## SUBDIVISION REVIEW SHEET

**CASE NO.:** C8-2013-0221.0A

**SUBDIVISION NAME:** Ross Complex Subdivision

**VARIANCE:** A variance to Land Development Code Section 25-4-151 Street Alignment and Connectivity is requested to not extend Spiers Way. The Land Development Code Section 25-4-151 requires that new streets in a subdivision align with and connect to existing street. The applicant proposes to not extend Spiers Way east to connect to Ross Road. The applicant has been in contact with the adjacent neighborhood association, the Berdoll Farms Homeowners Association, and the neighborhood group supports the variance. The neighborhood association is concerned with the additional traffic the road connection would generate and are satisfied with the existing road connections. Refer to the attached support material provided by the Berdoll Farms Homeowners Association.

**EXHIBIT "A"**

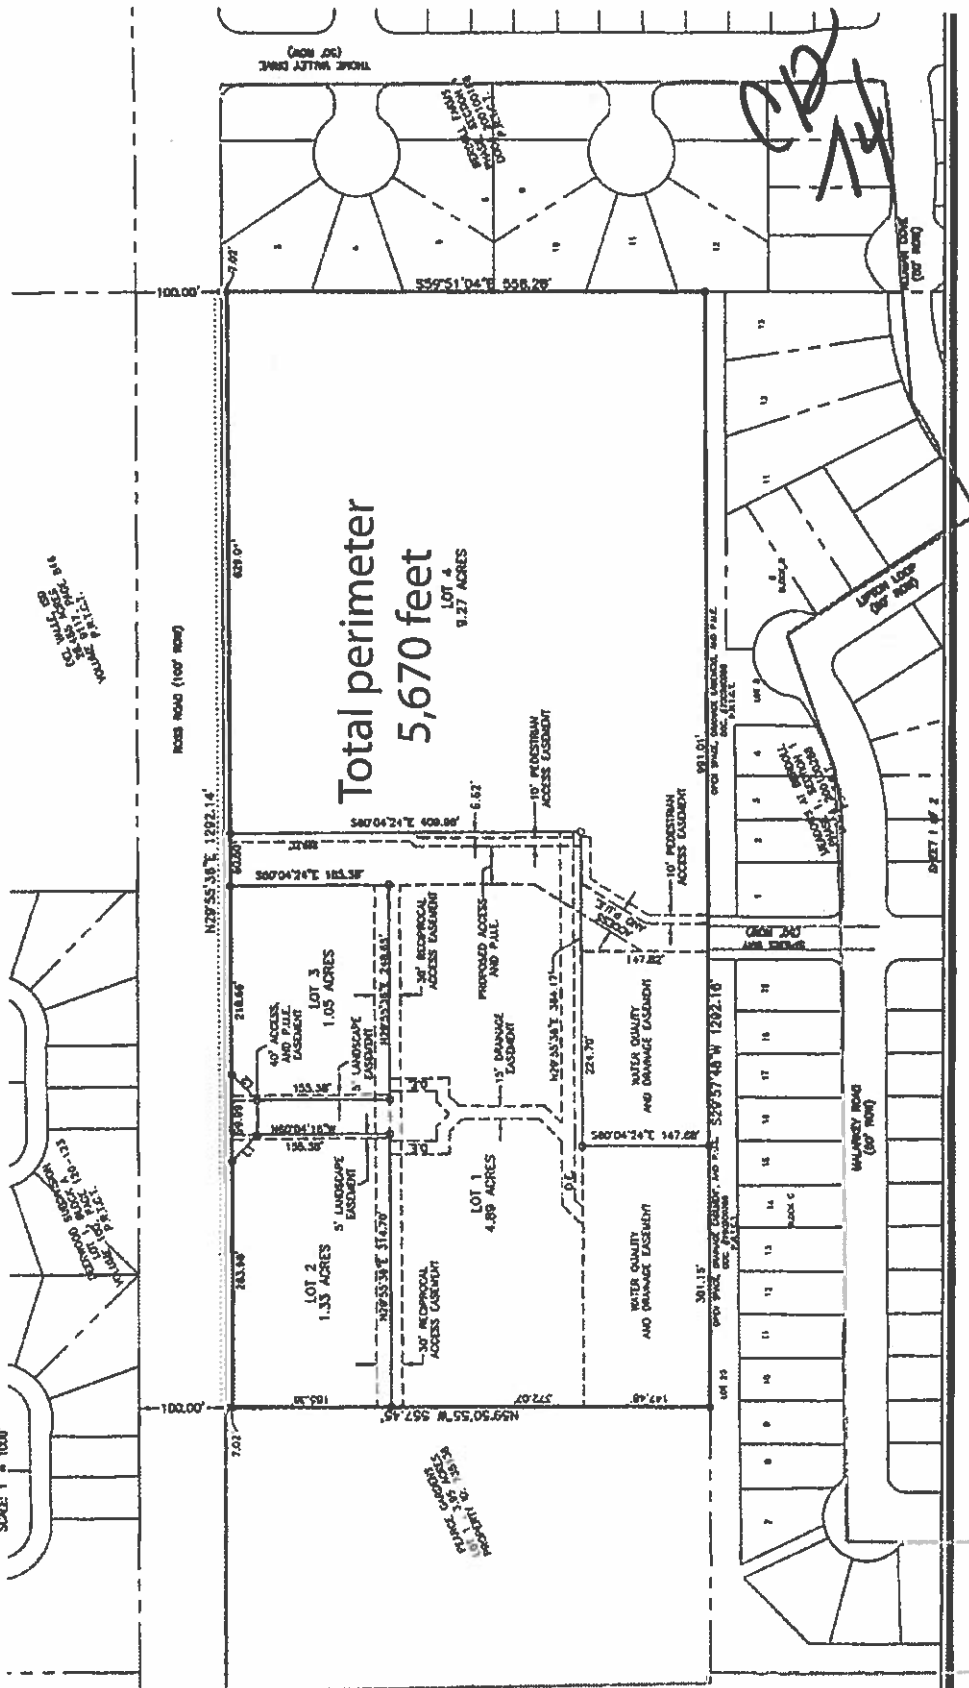
- Dead-end roads to a maximum of 150'
  - **Analysis:** Not extending Spiers Way into the Ross Complex subdivision inflicts on a neighboring site a dead-end road which exceeds 150' should any mechanism be used to restrict access on the road (such as through gating, not providing maintenance of the right-of-way, etc.).

- **PC Recommendation:** Deny the request for a variance for Spiers Way to be constructed as a private drive. Extend Spiers Way as a public road through the Ross Complex Subdivision to Ross Road.

- Minimum 2 access streets; if scale of development does not generate a complete block a stub may be required to allow for future connections
  - **Analysis:** public access is only provided to Ross Road, limiting external access for site.

- **PC Recommendation:** Deny the request for a variance for Spiers Way to be constructed as a private drive. Extend Spiers Way as a public road through the Ross Complex Subdivision to Ross Road.

- Connection of all constructed and paper stubs through site
  - **Analysis:** Spiers Way is constructed as access and public utility easement.
  - **PC Recommendation:** Extend Spiers Way as a public road through the Ross Complex Subdivision to Ross Road.

**EXHIBIT "C"**

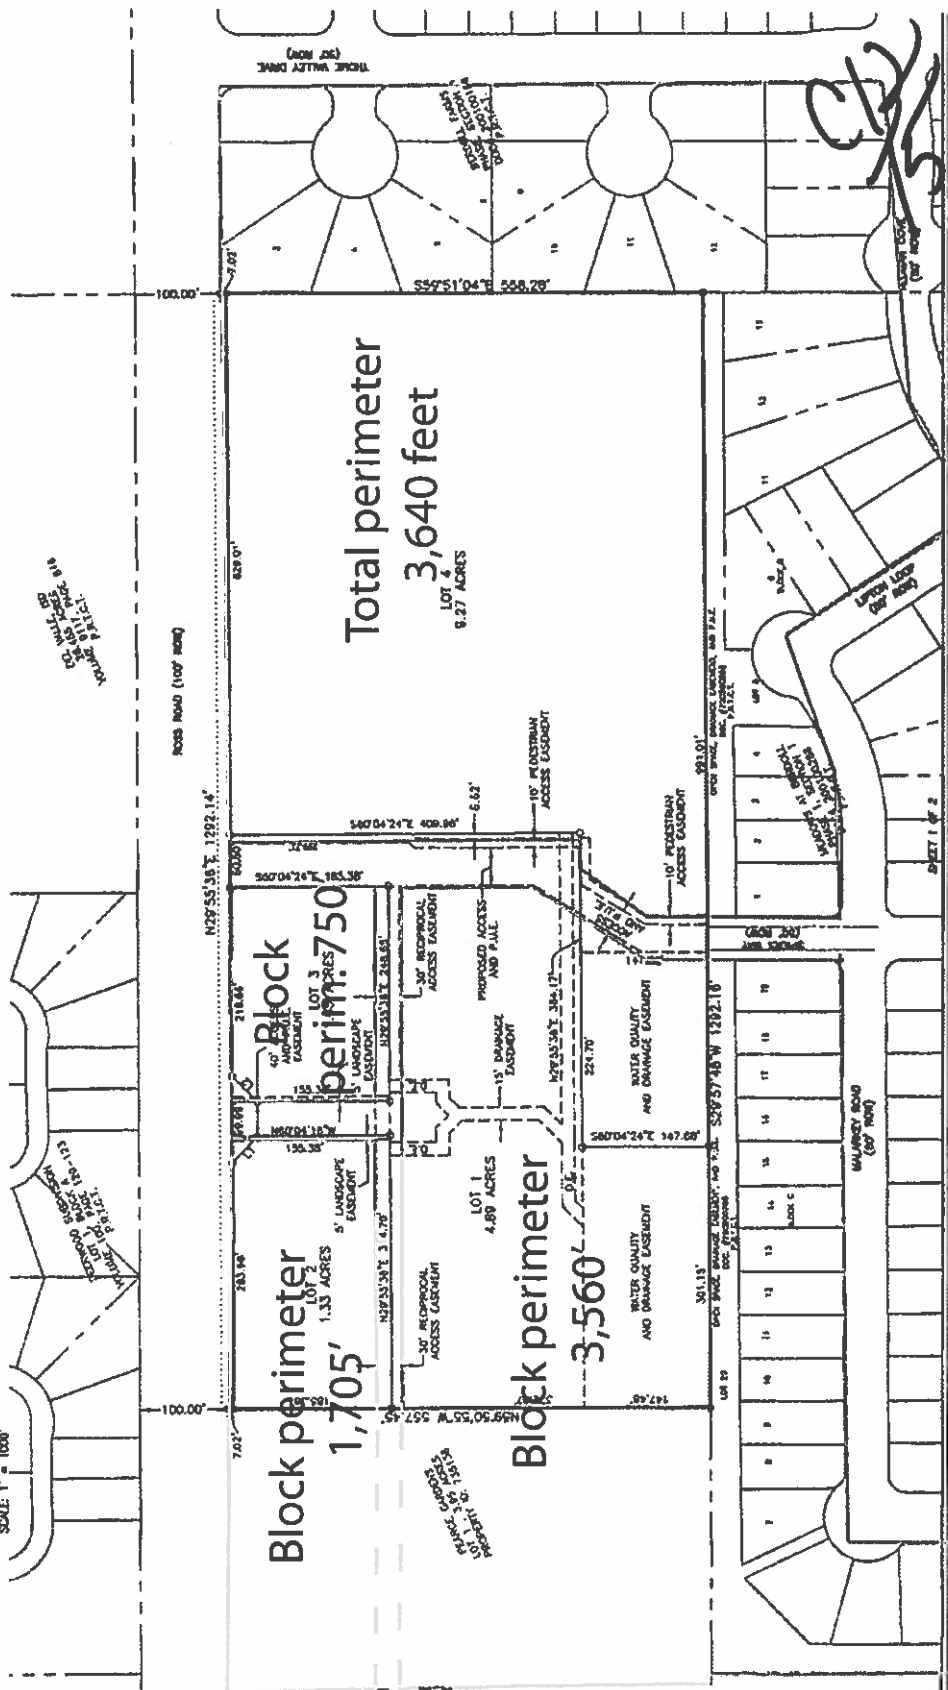
- **Analysis:** The pedestrian easement provides additional access through the Ross Complex Subdivision, however, not extending Spiers Way creates an unnecessary 1,890' block length, more than 200% of the maximum.

- **PC Recommendation:** Deny the request for variance. Extend Spiers Way as a public road through the Ross Complex Subdivision to Ross Road.
  - **Applicant Recommendation:** Provide additional pedestrian access along the east-west reciprocal access easement to provide for convenient, safe and direct pedestrian access to the Pearce Gardens Subdivision (**See Exhibit C**).

Figure 1. Google photograph of the Spiers Way stub street looking into the proposed subdivision and toward the Del Valle Elementary School.

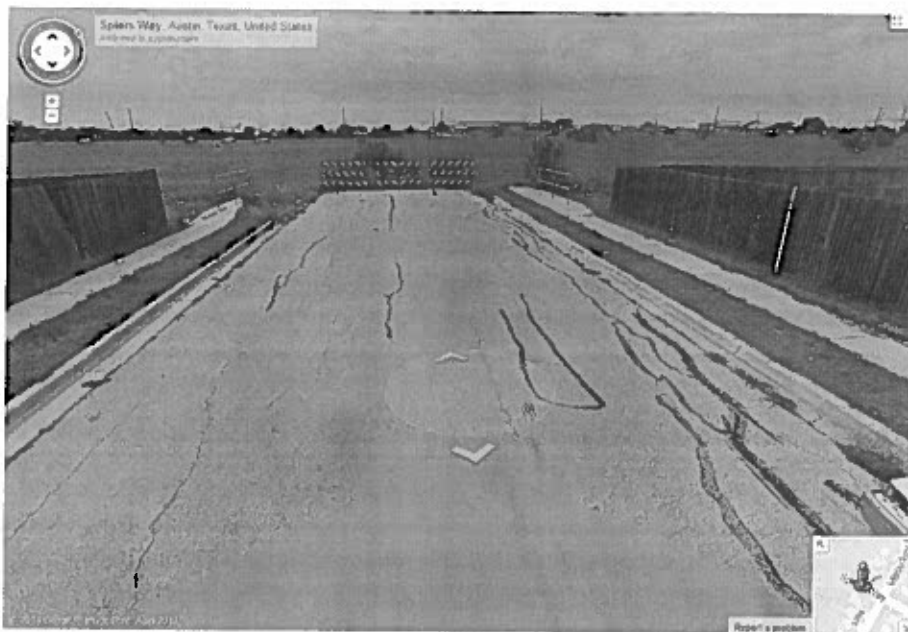
1. Connecting Spiers Way to Ross Road provides for a pedestrian connection as required by current Subdivision Regulations. Figure 1 below shows the existing stub street.

Figure 2. Private drives do not create legal crossing points or effective pedestrian connections. A private drive does not enhance pedestrian connectivity.

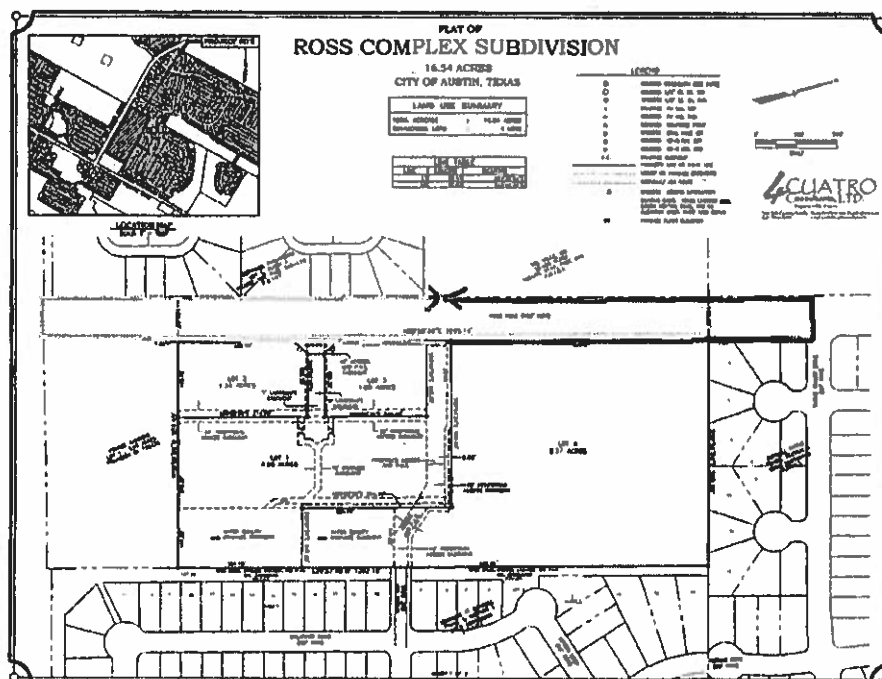
3. A private drive would not create a legal crossing point at Ross Road. Instead, individuals will still have to navigate to the North or South in order to legally (and safely) cross Ross Road at either Thome Valley Drive or Pearce Lane. This creates additional time barriers to pedestrianism of approximately 10 minutes. Figure 2 below illustrates in red and green the required pedestrian travel pathways in order to cross Ross Road if approaching through the proposed private drive.

Figure 1. Google photograph of the Spiers Way stub street looking into the proposed subdivision and toward the Del Valle Elementary School.

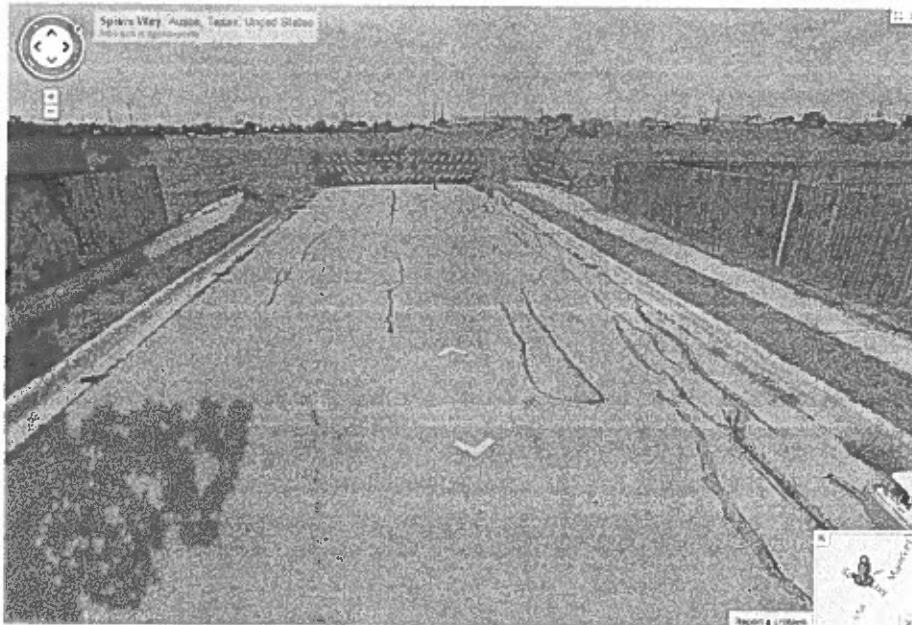
1. Connecting Spiers Way to Ross Road provides for a pedestrian connection as required by current Subdivision Regulations. Figure 1 below shows the existing stub street.

Figure 2. Private drives do not create legal crossing points or effective pedestrian connections. A private drive does not enhance pedestrian connectivity.

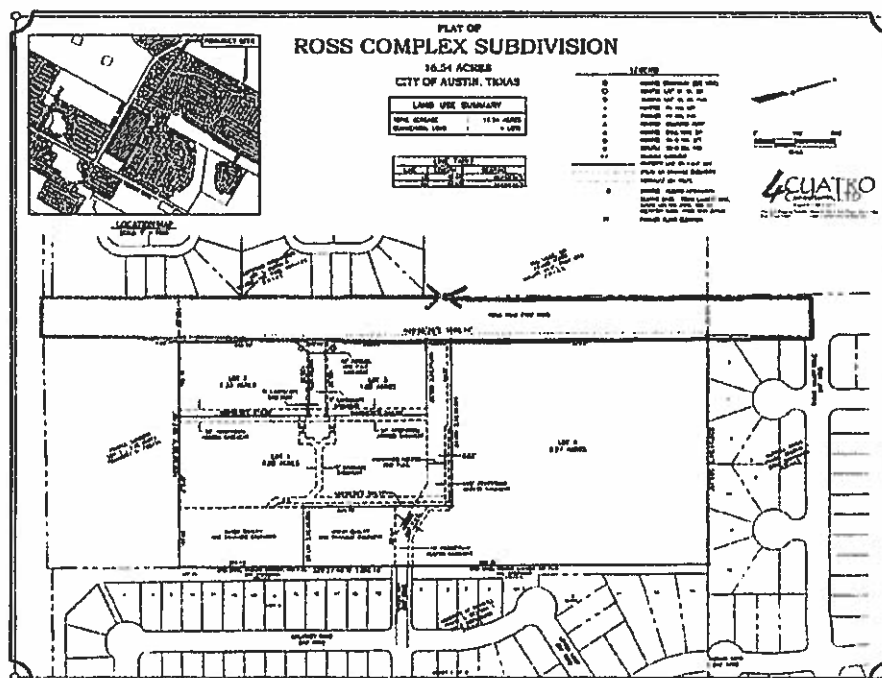
3. A private drive would not create a legal crossing point at Ross Road. Instead, individuals will still have to navigate to the North or South in order to legally (and safely) cross Ross Road at either Thome Valley Drive or Pearce Lane. This creates additional time barriers to pedestrianism of approximately 10 minutes. Figure 2 below illustrates in red and green the required pedestrian travel pathways in order to cross Ross Road if approaching through the proposed private drive.
